SUBJECT: Transmittal of Responses to AP1000 DSER Open Items

**AP1000 Design Certification Review
Draft Safety Evaluation Report Open Item Non-Proprietary Responses**

DSER Open Item Number: 3.7.2.3-1 (Revision 1)

DSER Open Item Number: 3.8.5.4-1 (Revision 1)

Figure 3.7.2.3-1-1: ASB Stick portion of NI combined model

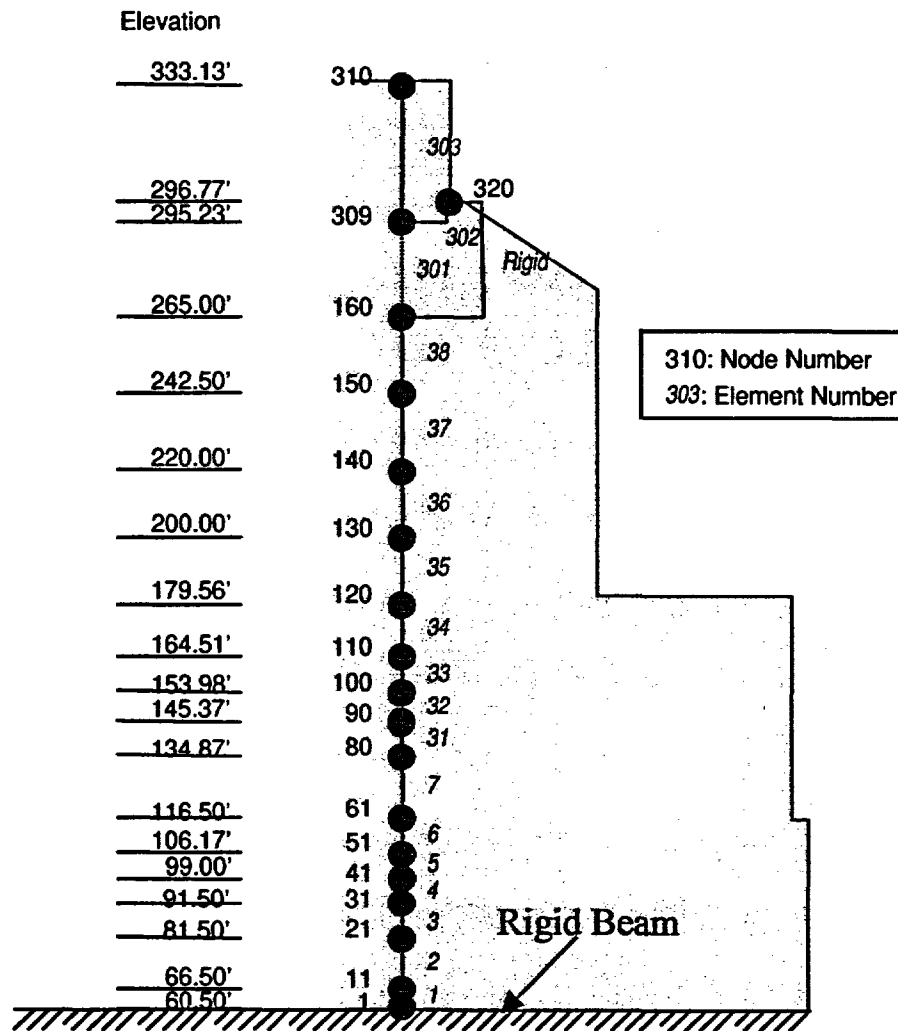
In resolving this issue, the staff, during the meeting conducted on April 2, 2003, explained its concern and expectation to the applicant regarding the significance of uplift due to seismic excitation of the NI and the effect of reduction of stiffness of shear walls. The discussion reached the following conclusions:

- The applicant will use East-West lumped-mass stick model of the NI structures supported on a rigid plate with nonlinear springs that transmit reactions in horizontal and vertical directions to simulate the foundation contact area, and perform a seismic time history analysis (the nonlinear springs will be in action only when the rigid plate is in contact with the subgrade). The results of this seismic time history analysis will be compared against the peak accelerations and the floor response spectra at the lumped mass node points obtained from the current three dimensional model analysis without the uplift consideration. If the comparison shows differences, the applicant should evaluate the significance of these differences and their effects on the current seismic design.

The effect of liftoff was evaluated using an East-West lumped-mass stick model of the nuclear island structures supported on a rigid basemat with nonlinear springs. This model is shown in Figure 3.7.2.3-1-1 and Figure 3.7.2.3-1-2. The liftoff analysis model consists of the following two elements:

The size of the equivalent rectangular basemat having the same overturning inertia as the nuclear island basemat is 140.0' × 234.5'. The basemat is modeled as a rigid beam, using 20 elements each 7 feet apart. Hard rock with a shear wave velocity of 8000 feet per second is modeled as horizontal and vertical spring elements with viscous damping at each node of the rigid beam. As shown in Figure 3.7.2.3-1-2, the NI combined stick is attached to the rigid basemat at the NI gravity center, which is about 9 feet from the center of the rigid basemat. In north-south direction, the stick is fixed at the bottom (EL. 60.5'). The stiffness properties of the

FIGURE 3.7.2.3-1-11: ADDING SOIL MASS ELEMENT

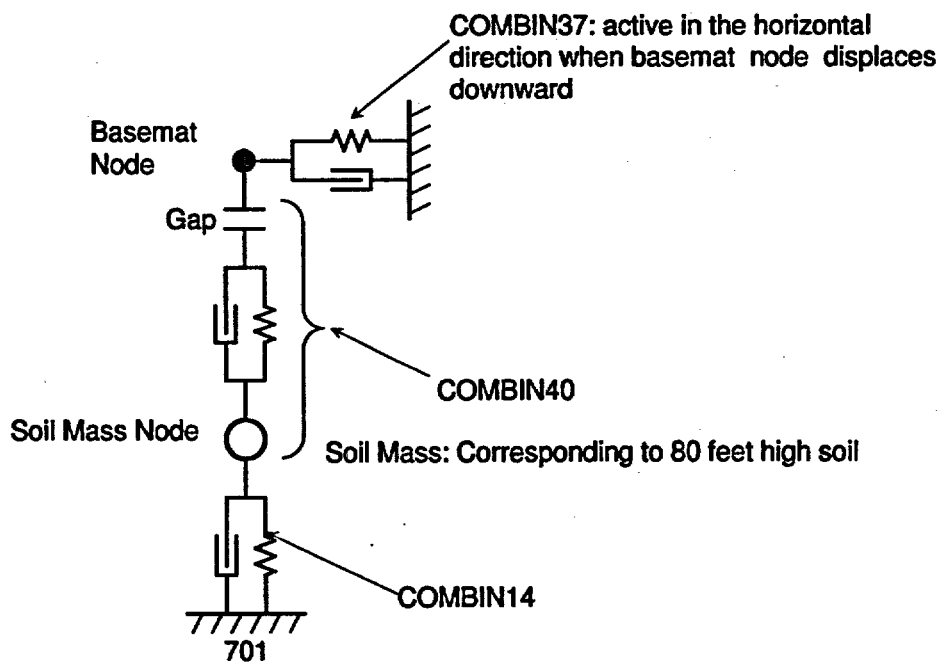
During the telephone conversation of mid August, 2003, the NRC staff commented that the "slapping" phenomenon that occurs during liftoff was not being addressed fully because the existing liftoff model did not include independently acting soil masses.

In order to investigate the effect of soil mass, gap elements representing soil 80 feet deep were added to the existing liftoff model as shown in Figures 3.7.2.3-1-11. The horizontal and vertical floor response spectra at representative elevations of the auxiliary and shield building are shown in Figures 3.7.2.3-1-12 through 3.7.2.3-1-15. The results show that the soil mass effects are insignificant in the horizontal direction. These effects are also insignificant in the vertical direction at the higher elevations, and are very small at the lower elevations.

Figure 3.8.5.4-1-1
Free-body Diagram for Containment Internal Structures Overturning Evaluation

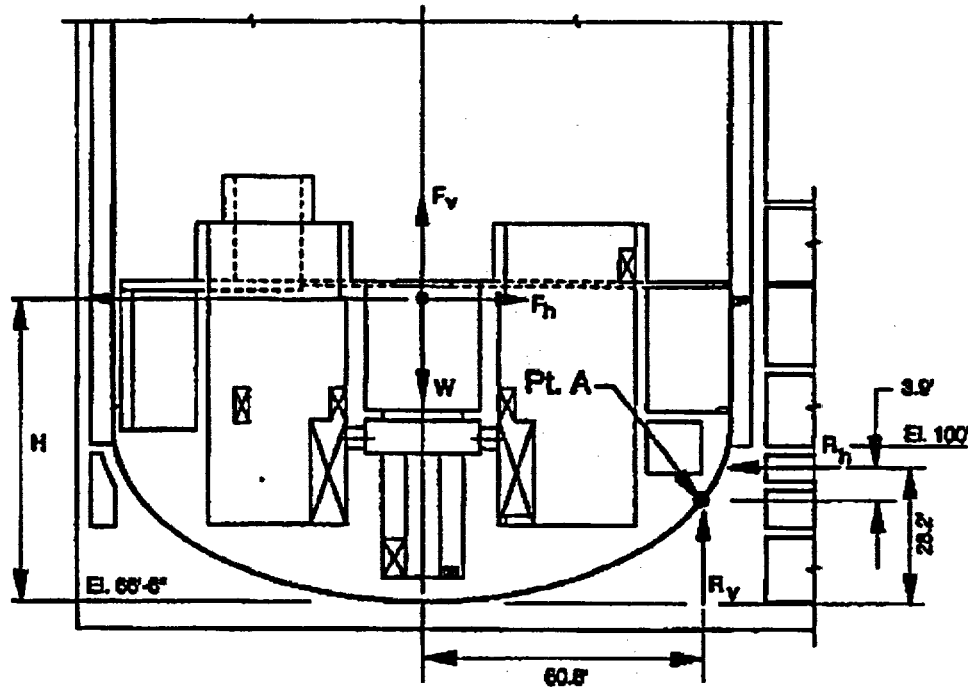
In its review of DCD Tier 2 Section 3.8.5.4, the staff determined that the potential uplift and slapping back of the containment internal structures foundation on the basemat through the steel containment vessel during a seismic event could affect both the seismic design loads and in structure response spectra for all structures, systems and components associated with the containment internal structure, and could also affect the seismic response of the steel containment shell. In RAI 220.021, the staff requested the applicant to perform additional analyses to demonstrate how the uplifting effect will be addressed, and how the uplifting effect on the seismic analysis results will be used for the design of the containment and containment internal structures. This is Open Item 3.8.5.4-1.

The bottom head of the containment vessel rests on the nuclear island basemat. The containment internal structures basemat rest within the bottom head. There are no shear studs or anchors designed to transfer loads tangential to the vessel surface. The interface is designed to transfer load in compression and friction. The configuration is identical to the AP600 and the stability evaluation shown in Figure 3.8.5.4-1-1 follows the AP600 methodology described in the AP600 response to RAI 230.47.
